SUBJECT: Coastside Design Review  
Miramar Drive and Terrace Avenue, Miramar  
APN 036-282-050; County File No. PLN 2016-00337

At its meeting of January 12, 2017, the San Mateo County Coastside Design Review Committee (CDRC) considered your application of a design review recommendation to allow construction of a new 2-story 3,546 sq. ft. single-family residence with an attached 487 sq. ft. 2-car garage, including a 1,152 sq. ft. 2nd Unit with a detached 400 sq. ft. carport, on an existing 22,337 sq. ft. legal parcel (COC PLN2015-00444), as part of an "After-the-Fact" staff level Coastal Development Permit (CDP) for removal of seventeen (17) trees, in order to resolve VIO2016-00141. The 2<sup>nd</sup> Unit is a ministerial project that does not require review by the CDRC and will be considered at staff-level. Only minor grading is proposed. Seventeen (17) existing significant trees are proposed for removal. The project is not appealable to the California Coastal Commission.

LOWER LEVEL FLOOR PLAN

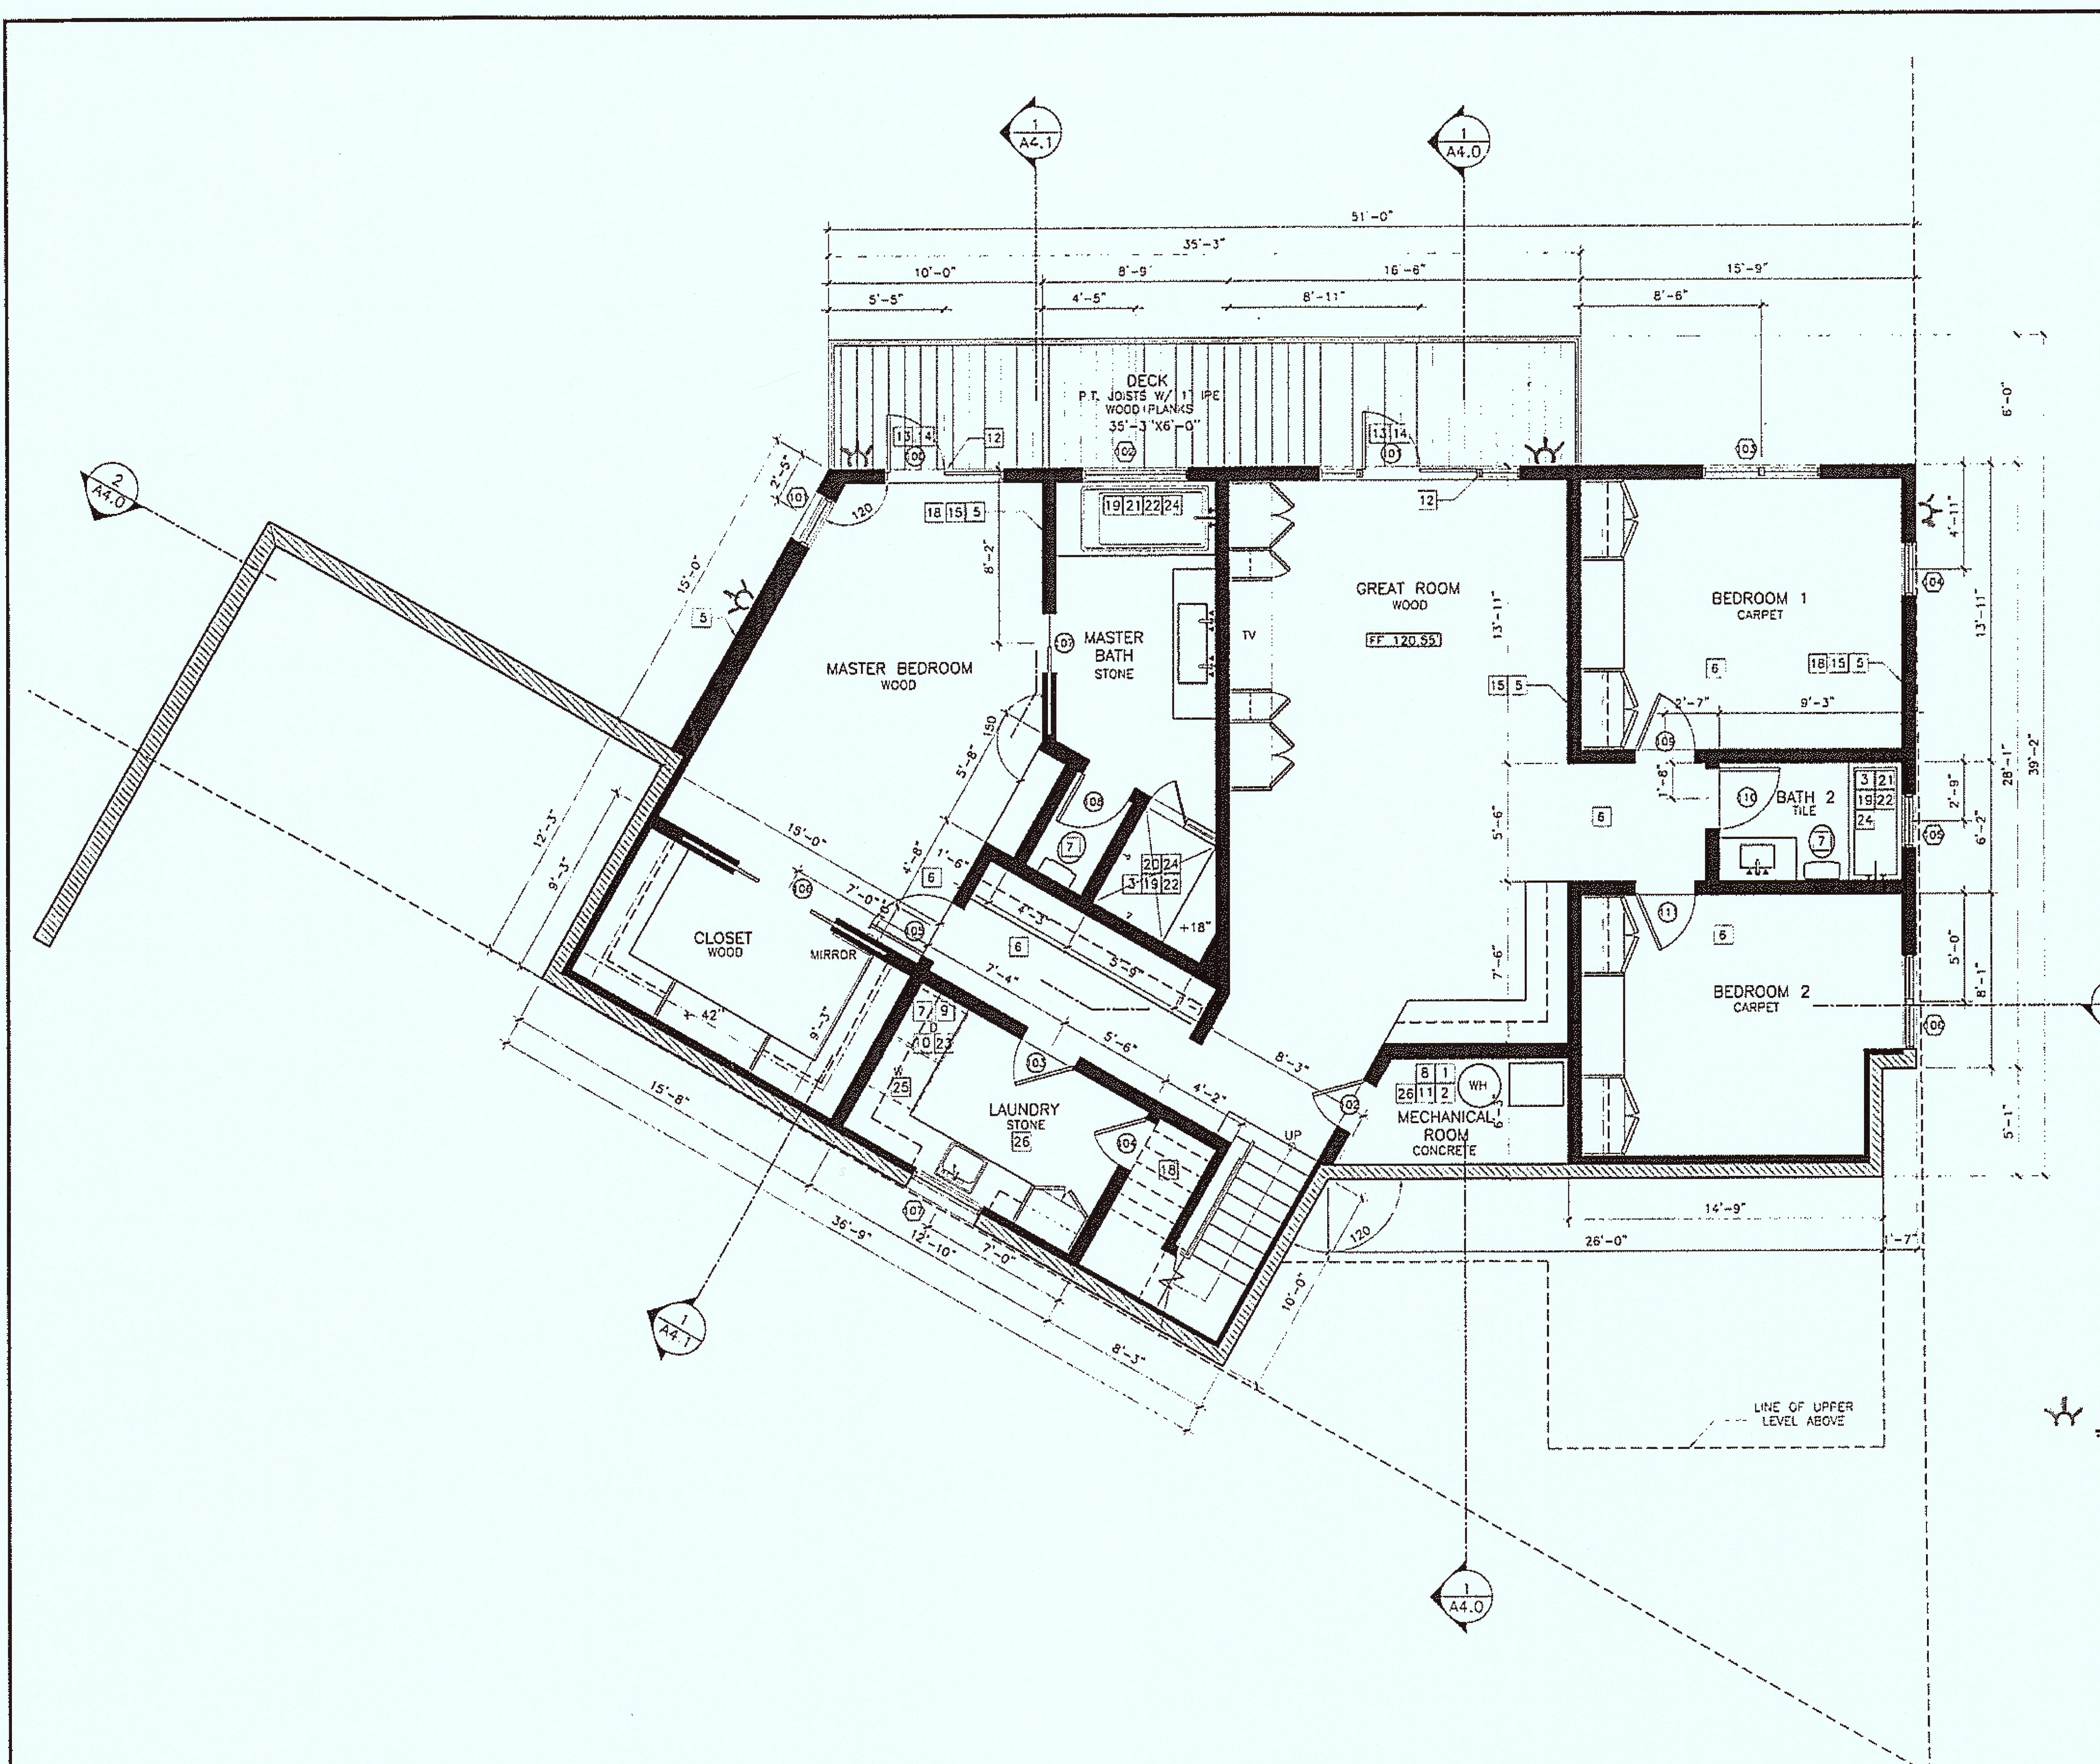
- a. Section 6565.20(F). 4c. Exterior lighting should be minimized and designed with a specific activity in mind so that outdoor areas will be illuminated no more than is necessary to support the activity designated for that area, i.e. one light per exterior door. Indicate location of exterior light fixtures on the floor plans.
- b. Section 6565.20(D). 4a3. Use warm, muted colors and natural appearing materials on the house that blend with the surrounding natural features when viewed from a distance. Provide samples of cedar stain and color chips.
